PROJECT TITLE: PUBLIC SPACE AT MARKET SLIP & HARBOUR PASSAGE EXTENSION	ADD. NO: 2
TENDER NO: 2022-081201T	DATE: July 7 th , 2022
PAGE 1 of 2 (Including Confirmation Sheet)

Public Space at Market Slip & Harbour Passage Extension

ADDENDUM NO: 2

CONTRACT NO: 2022-081201T

1 PATIO - VENTILATION
M4.2 1/8" = 1'-0"

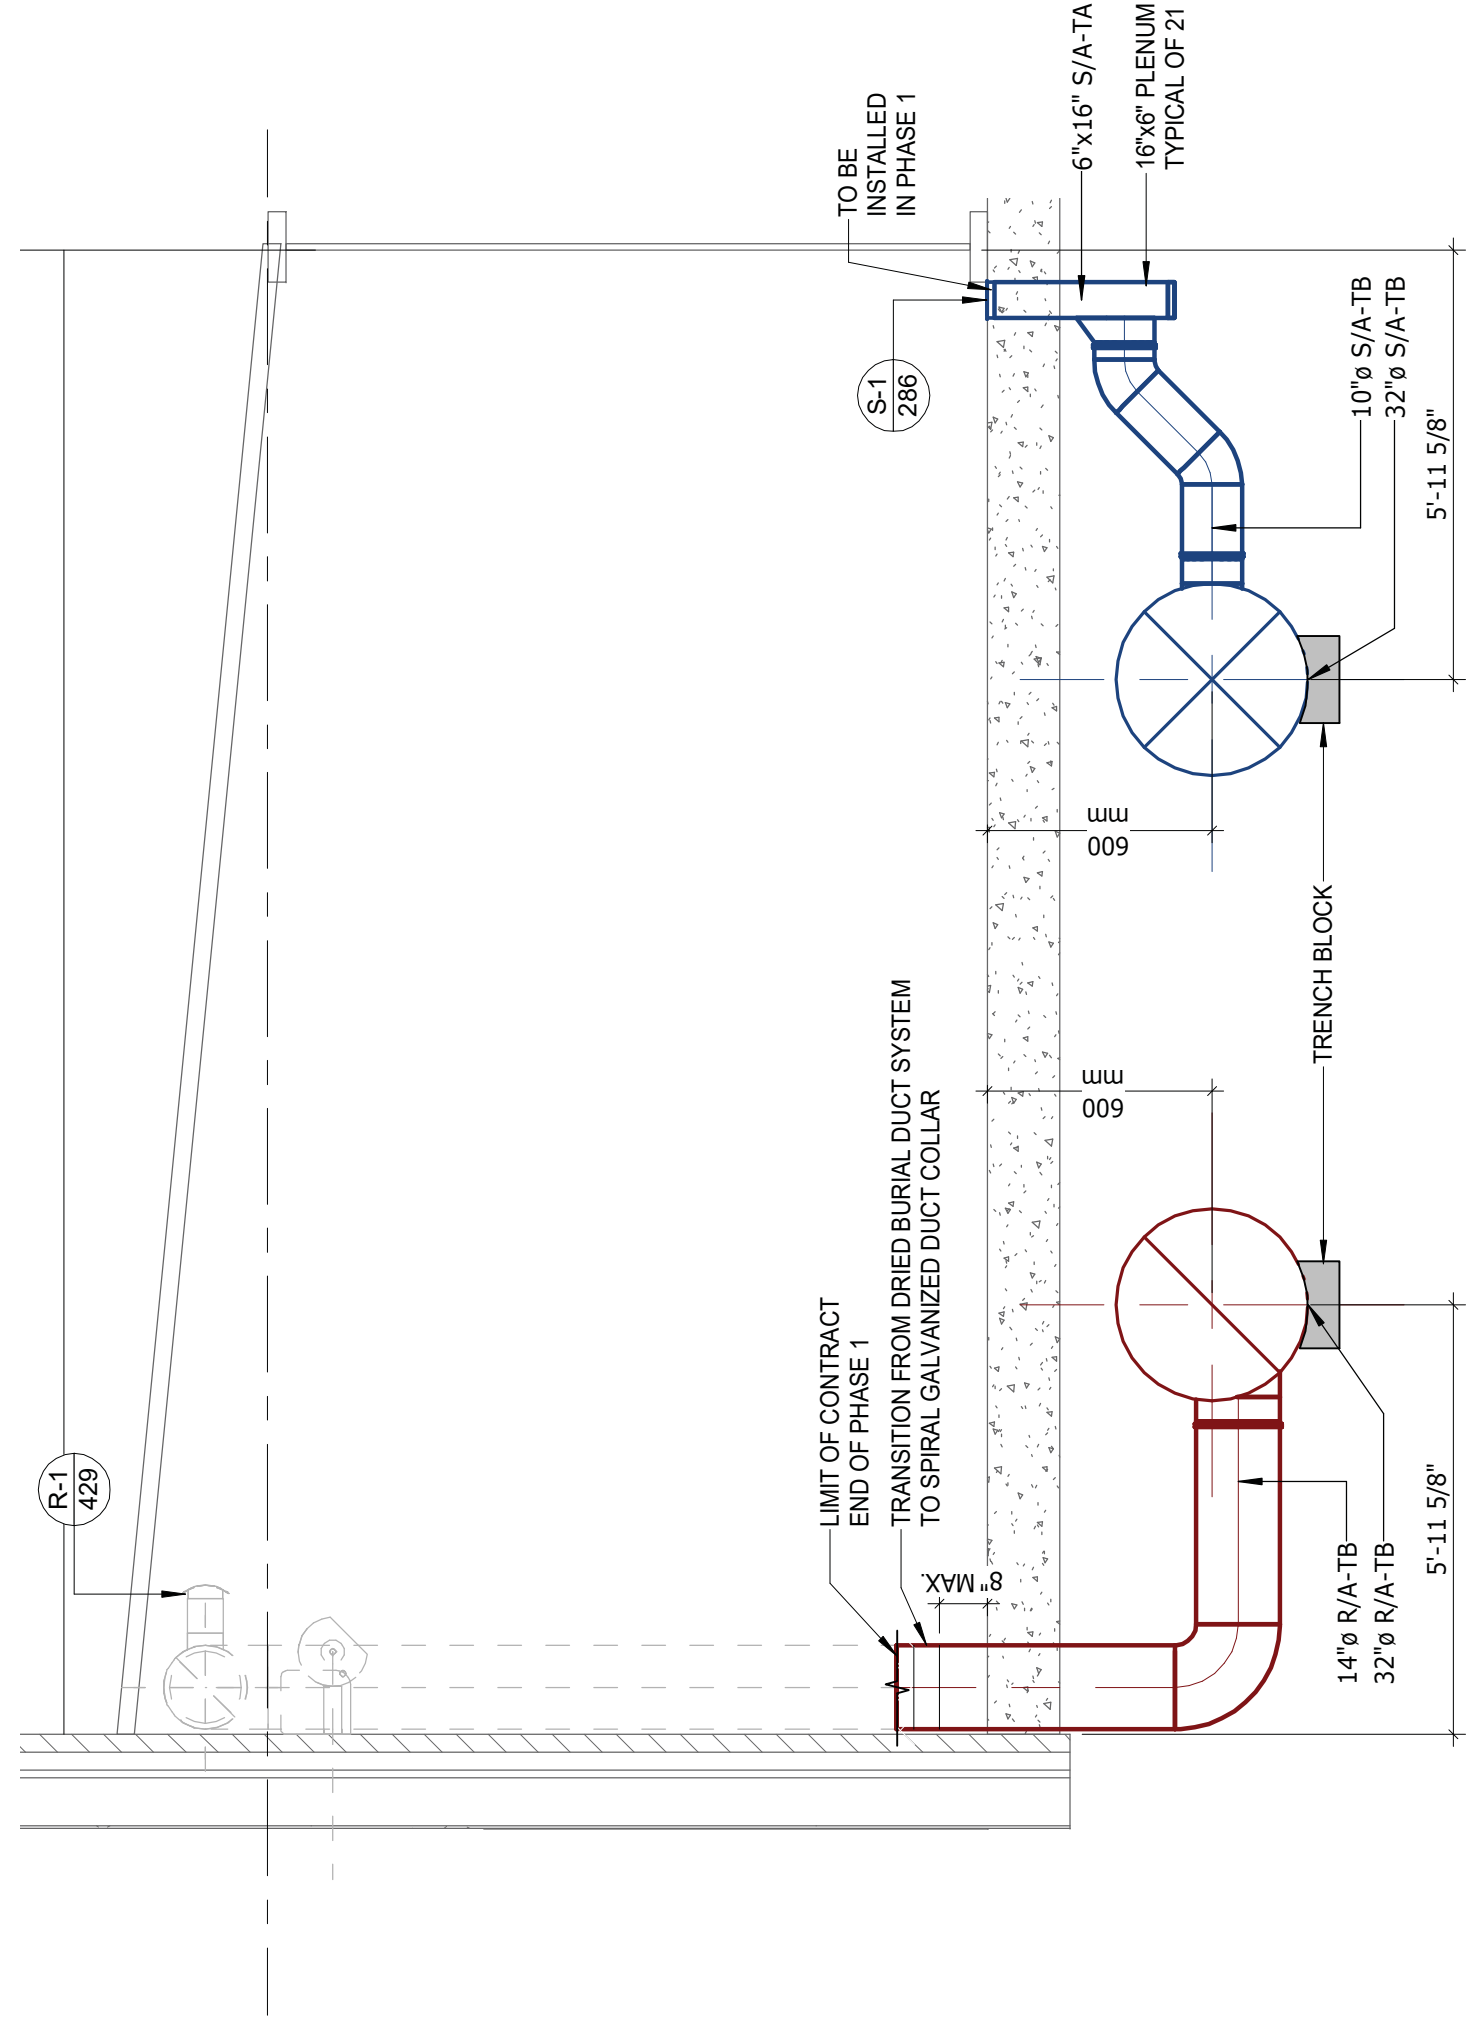
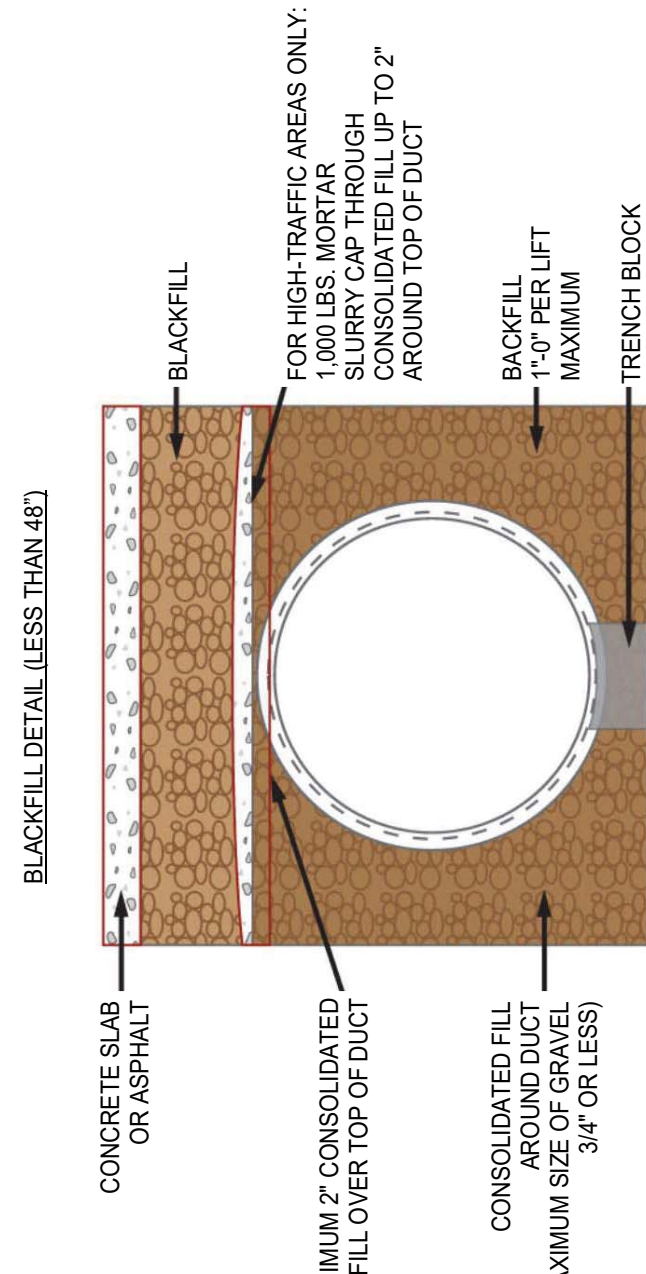
The attached drawings M4.1, M4.2 and M4.3 have been added to the drawing package. The work shall entail all underground ventilation - HDPE direct burial duct system. The price of this work shall fall under Division 4.5 MISC item no 6.
